Service Manual

Supplement

Video Product

Subject :Change of IC

Figure 1

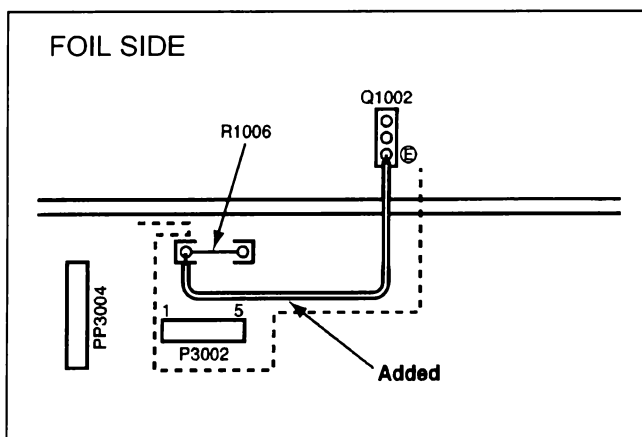
Symptom : As a result of the severe short-circuiting safety test of each circuit, the operation malfunction occurs in the extremely low probability.

Remedy : To improve this symptom, 2 jumper wires have been added as shown below.

1. Between the Emitter of Q1002 and R1006. (Refer to Figure 1)
2. Between the Emitter of Q6011 and Anode of D6008. (Refer to Figure 2)
